SUBJECT: SERVICE BULLETIN S12VS SCR/DPF ISOLATORS MAY FAIL

AFFECTED: CERTAIN 2012 THROUGH 2014 MODEL YEAR VISION BUSES

2012-2014 BBCV SCR & DPF Isolators

Figure 1

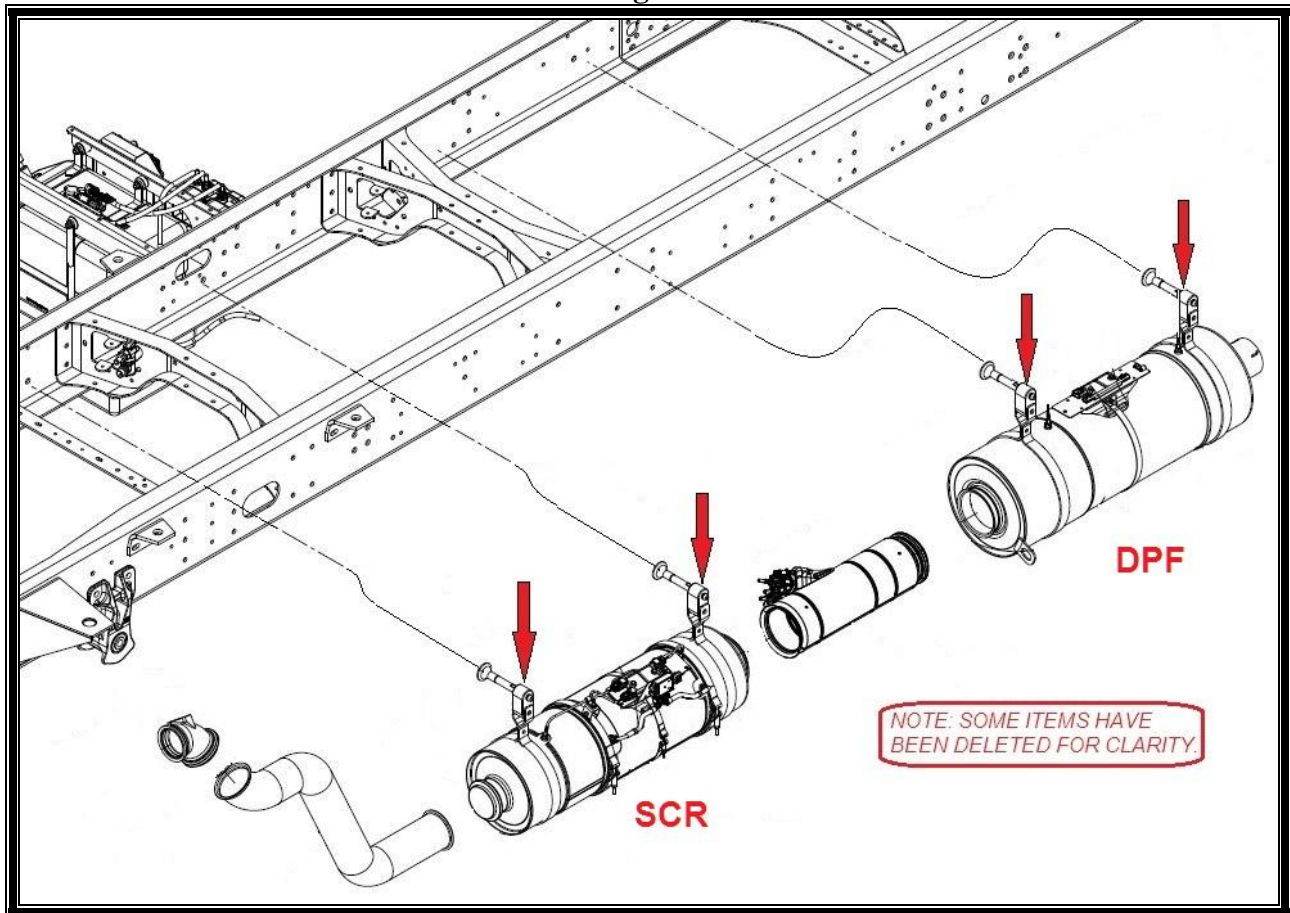
Exhaust isolator(s) may fail that support the SCR (Selective Catalytic Reduction) and/or DPF (Diesel Particulate Filter).

3. There will be red silicone exhaust isolators located above the SCR & DPF. One at either end of each component. These are identified by the red arrows in Figure 1.

Replace all SCR & DPF isolators, inspect the remaining exhaust system and re-torque all band clamps.

Figure 2

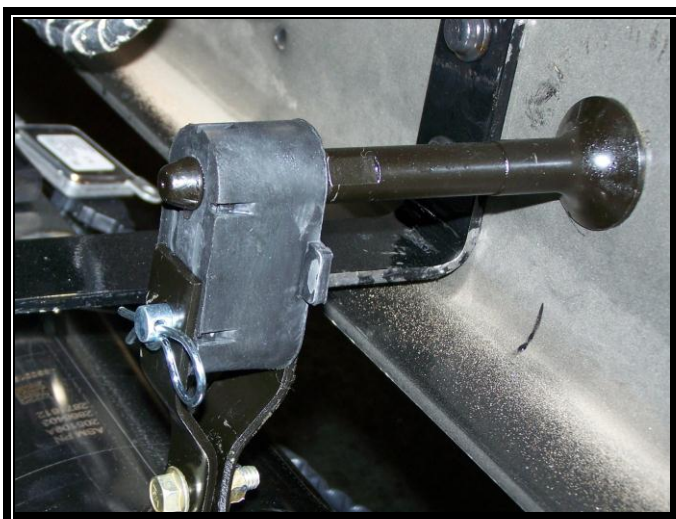
4. Place a wood spacer and jack under the component and raise enough to allow the isolators to relax. Very little movement, if any will be seen.
5. Beginning with the forward most isolator, remove the pull pin, remove the pin in the bottom isolator hole, rotate the isolator 90 degrees, and remove the isolator from the hanger bracket by pulling towards the center of the frame. Refer to Figure 2 and Figure 3.

6. Locate new isolator; it is colored black and is an EPDM synthetic rubber material.
7. Holding the isolator at a 90 degree position, press onto hanger.
Note: The use of a silicone spray may be necessary to help the isolator slide onto the hanger.

8. Rotate the isolator down into the bracket, align and insert pin and secure with pull pin.
9. Repeat this process for the remaining three isolators, relocating the wood spacer and jack as necessary.
